Memorandum

To:	City of Greater Geelong	From:	Jason Stone (Traffix Group)
Our Ref:	G36342M-02A	Date:	5 th August 2026

277-279 Scenic Road, Highton Proposed Childcare Centre Development RFI Response

Appendix C – Concept Plan

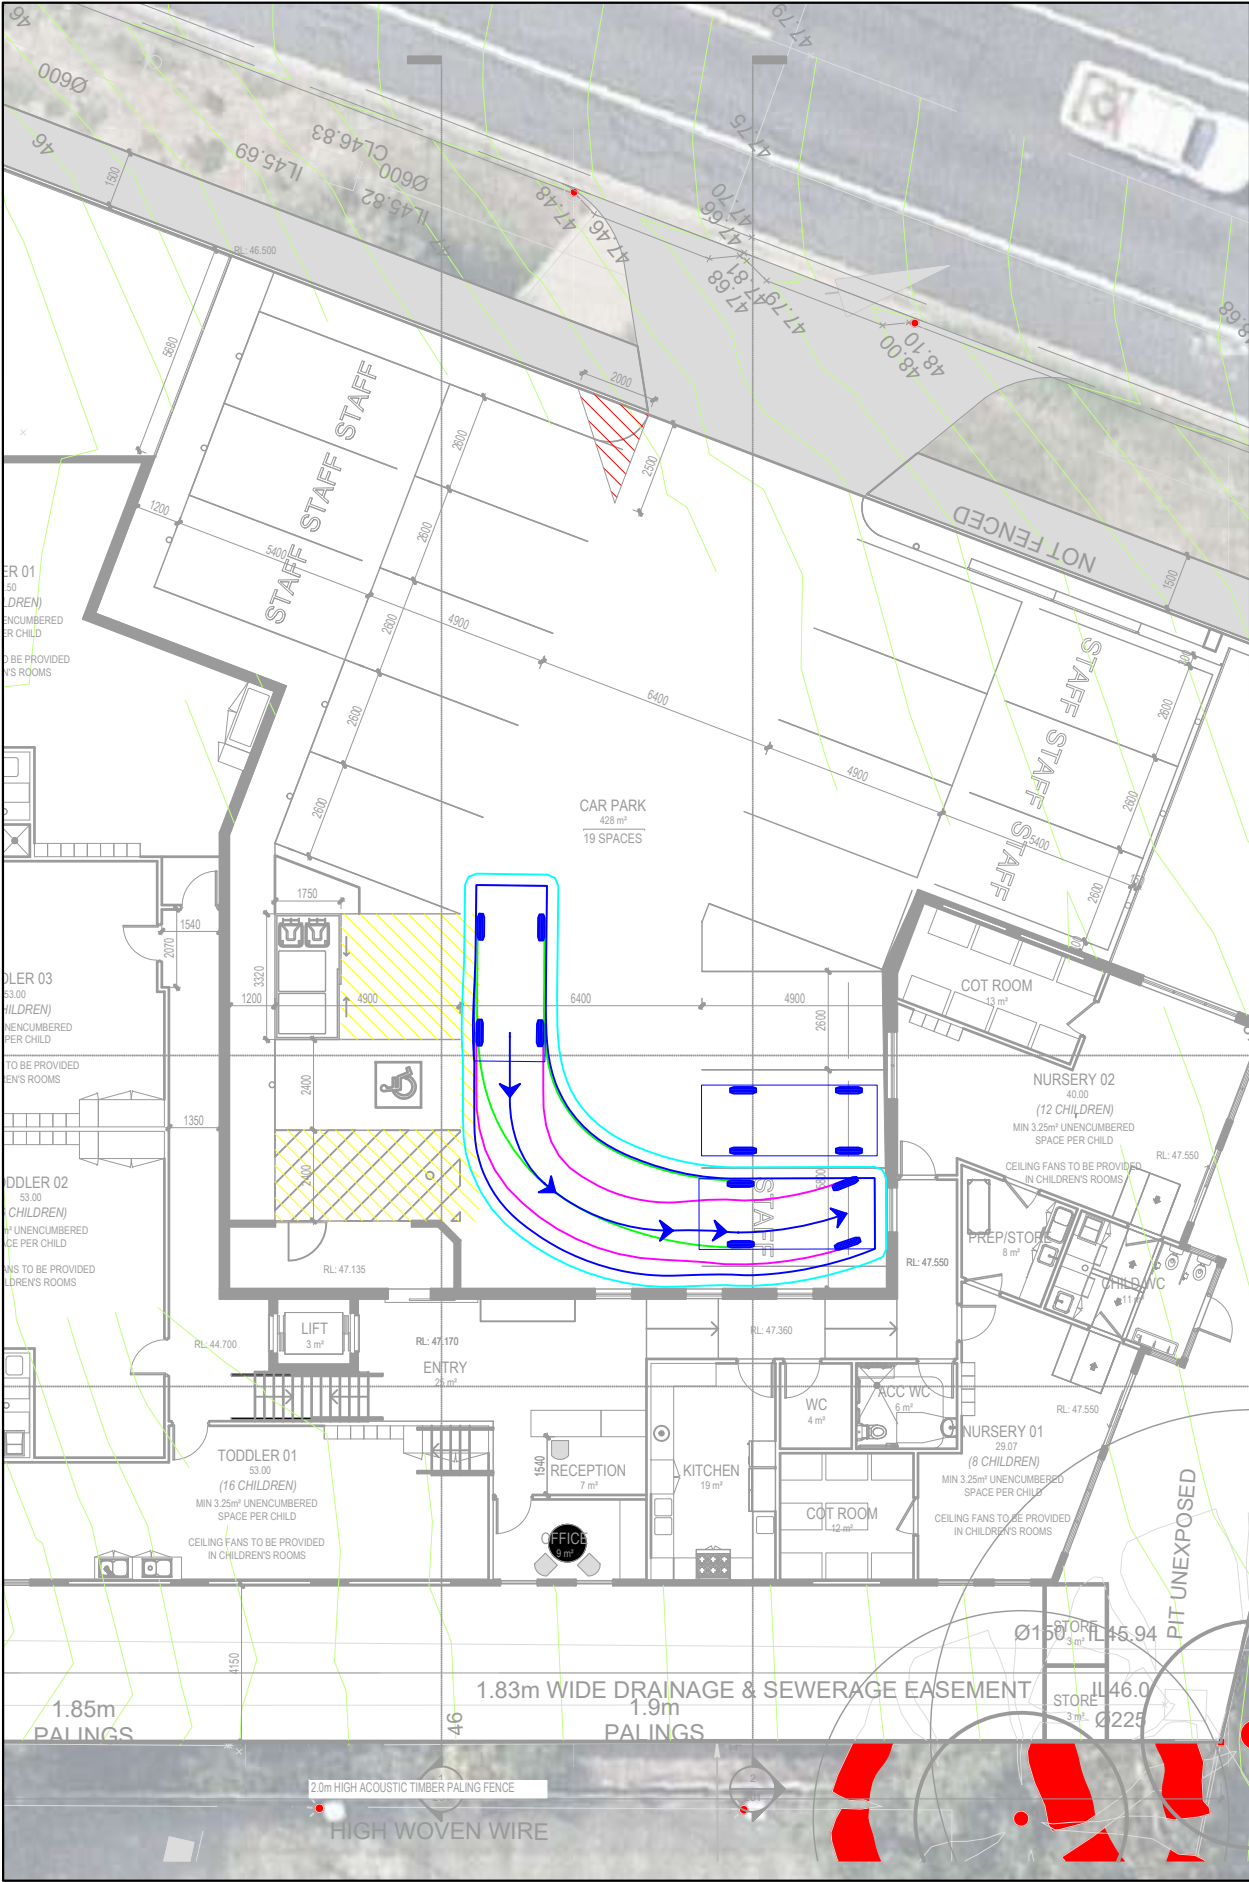
<i>The curve warning sign on this pole will have to be attached to a new steep post and this will be up to Dept. Transport and Planning where it is to be sited.</i>	The Concept Plan previously prepared by Traffix Group details this sign being relocated and DTP has provided acceptance of this drawing. This Concept plan is attached at Appendix C.
<i>The western-most internal car space is provided with a substandard blind aisle (see overleaf). AS/NZS 2890.1:2004 asks for a minimum 1.0 m long blind aisle, however this assumes an additional overhang. It is recommended that blind aisle be increased to 1.5 m and the building be protected by bollards or even with guardrail.</i>	We note that the 1m from the Australian Standard (AS/NZS 2890.1:2004) is not a mandatory requirement but a recommendation. The Australian Standard is not a mandatory document (unlike other design items within Clause 52.06-9, where appropriate) but a guideline for development and for designers to consider. The western-most car space is provided with dimensions that accord with Clause 52.06-9 of the Planning Scheme, being 2.6m wide by 4.9m long, with a 6.4m access aisle. A 0.6m extension is provided beyond the car space. Swept paths demonstrate that vehicles can access this single car space in 1 movement

<i>Without prejudice, a permit condition would be required for the 3 No. existing kerb laybacks/vehicle crossings in Scenic Rd that must be removed and verge reinstated.</i>	The removal of the 3 existing kerb laybacks/vehicle crossings in Scenic Rd is outlined in the development plans and Concept Plan. Additionally, the Concept Plan also identifies that a redundant layback via Willowfield Court be reinstated.
<i>Without prejudice, a permit condition would be required for the 3 No. parking spaces along the site's frontage to Willowfield Court to be constructed.</i>	There is no requirement for this to occur in our view. The proposal is compliant with its car parking requirement on the site already as outlined in the previous Traffic Engineering Assessment.

Appendix D – Swept Path Diagram

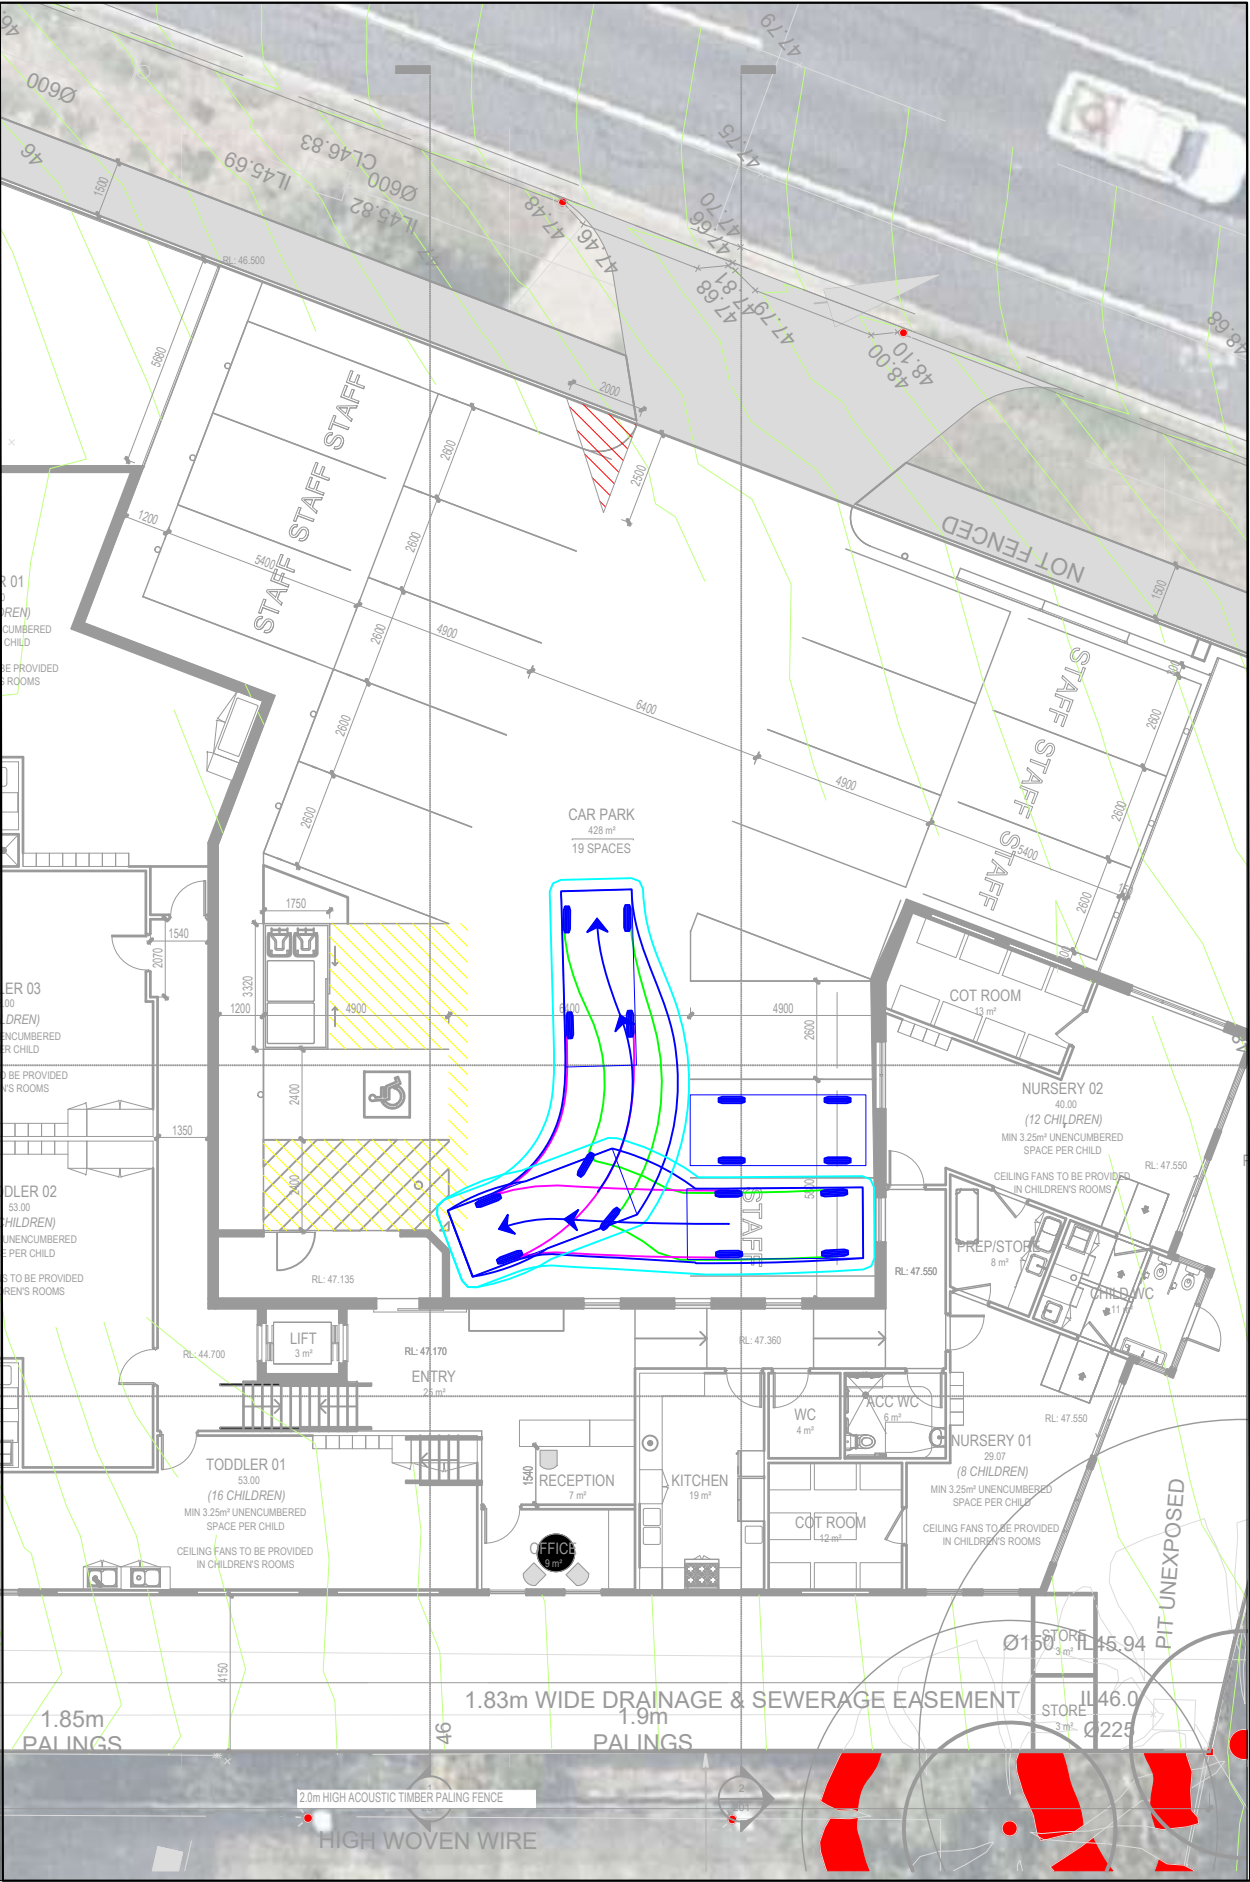
RFI Item	Response
	for entry and exit, which is acceptable. Additional blind aisle space is not required. In any event, to alleviate concerns, the car space has been labelled as a 'STAFF' car space to minimise its turnover and to ensure users are familiar with its access arrangements. An updated swept path diagram using the latest plans is provided at Appendix D. There is no requirement in this instance to increase the blind aisle length, nor provide bollards or guard rail to the building. As the space is dedicated to staff, turnover will be minimal and protecting the building itself is a management issue.
<i>The use of wheelstops where car spaces confront the building must be set 0.9 m from the wheel face to the building.</i>	The exact positioning of wheelstops will be performed by wheelstop licensed installer to ensure they are located as per AS2890.1-2004. This level of detail is not required for application drawings. In any event, a condition of any permit granted could manage the location of the wheelstops.
